Re: BSEACD's AS Staff's recommendations regarding the Needmore Water LLC/Needmore Ranch, LLC Application for a regular permit for domestic and agricultural purposes pursuant to HB 3405

July 8th e-mail from Vanessa Escobar transmitting the District's Aquifer Science Team's Technical Memorandum entitled "Evaluation for Potential and Reasonable Impacts: Needmore Water, LLC, Well B Permit Application" and the proposed "Special Provisions" for inclusion in the District's recommended permit for the Needmore Well B

Evaluation for Potential Unreasonable Impacts: Needmore Water, LLC, Well D Permit Application

Figure 1. Graphical presentation of drawdown versus time from the Needmore pumping alone at the Amos observation well (assuming Table 1 parameters). Note most of the drawdown occurs within the first year.

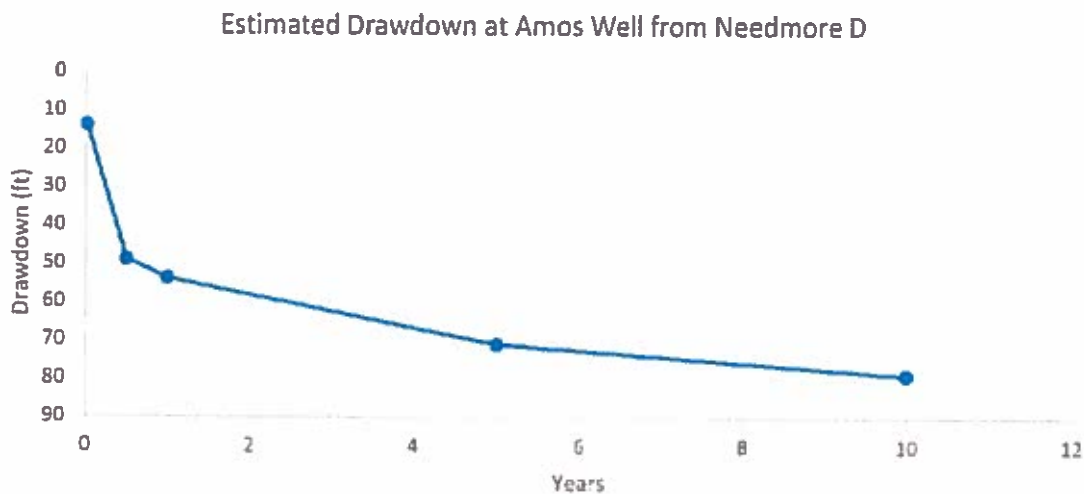
Using the aquifer parameters derived from the aquifer test (Table 1; Appendix A), the AS staff estimate the additional drawdown from the Needmore pumping over time in Figure 1. For the evaluation, AS staff choose drawdown from pumping during a 7-year period. This period was chosen to be representative of a severe drought when little recharge occurs, and capture is constrained. The results of the estimated drawdown at the Amos Well due to Needmore pumping is about 75 ft after 7 years (Figure 1).

In order to estimate the potential for unreasonable impact from the Needmore pumping, the full range of water-level variability in the area of influence must be considered and accounted for in the evaluation (Table 2). This includes an accounting of projected drawdown attributed to factors independent of the proposed production including drought variability and existing and future local pumping (Table 2). Combined with this existing water level variability of 50 ft (Table 2), the total projected drawdown (76 ft) is about 126 ft. The estimated additional drawdown from the Needmore pumping could lower the water level (heads) below the top of the Middle Trinity Aquifer in the Saddle Ridge area. The additional drawdown also puts the water level within 20 feet of the pump in the Amos well.

Figure 2. Potential Index Well Diagram and Compliance Levels

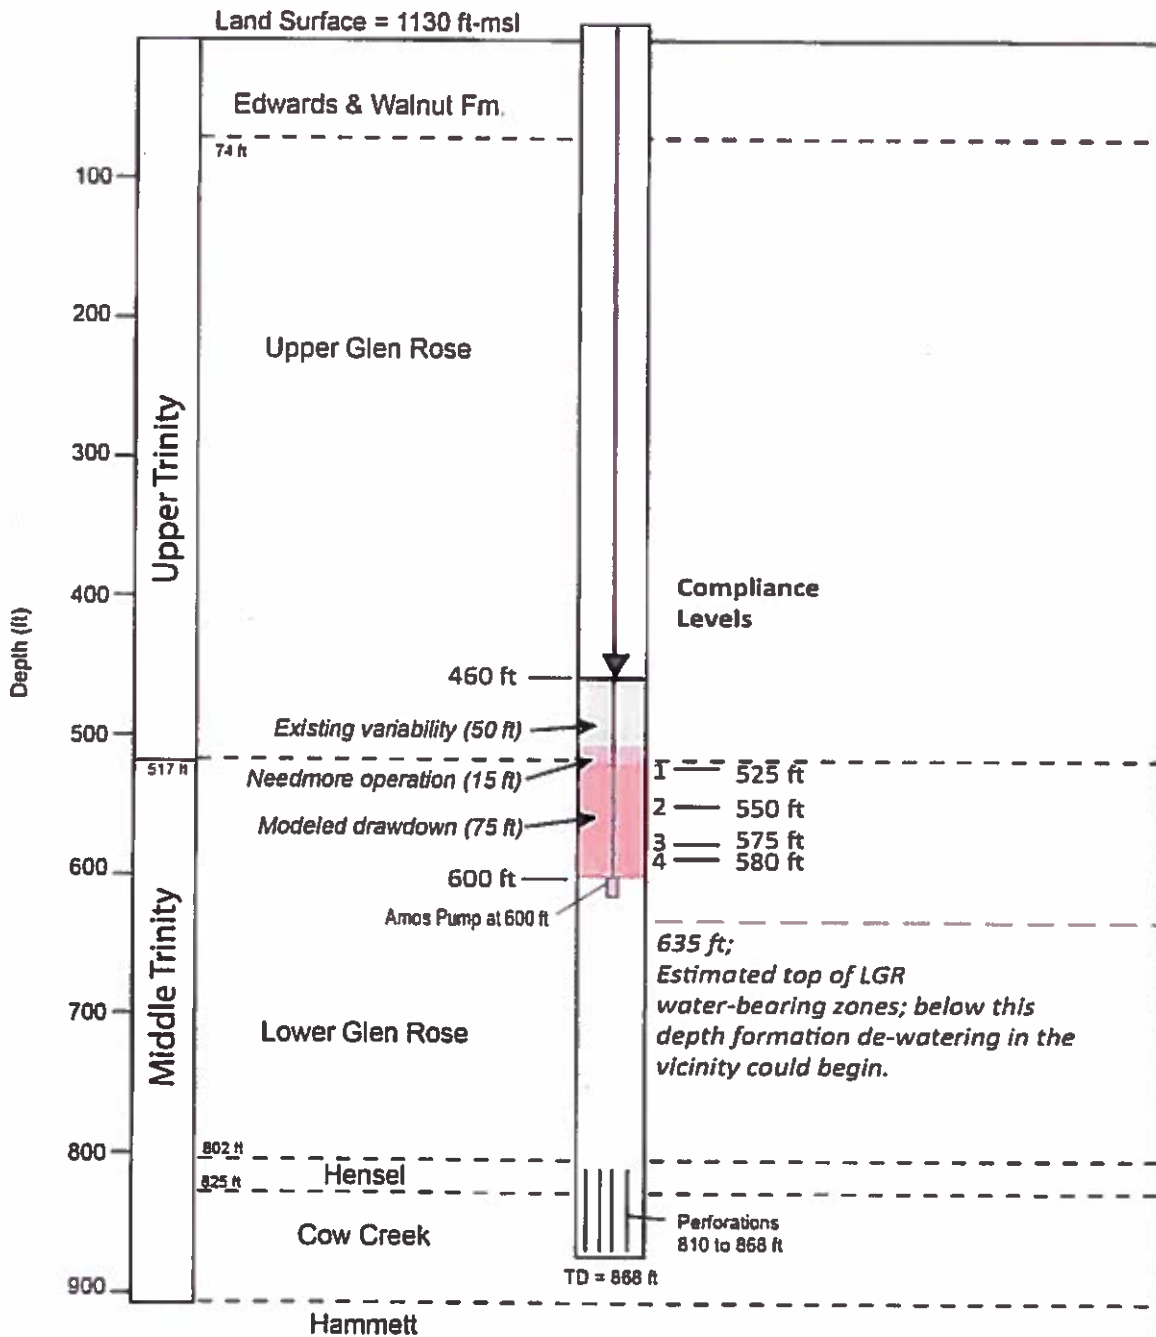
Table 3 presents a summary of the specific compliance levels derived for the Amos Well. Figure 2 is a graphical representation of the Amos Index Well and the corresponding compliance levels. Compliance levels were set after considering natural water level variability (Table 2; 50 ft) and also the observed short-term operational effects of pumping from the Needmore Well (~15 ft). Thus, this allows for up to about 65 ft of variability below the average water level before crossing the first compliance level threshold. Figure 3 is a conceptual diagram showing how each compliance level is distributed over depth and time.
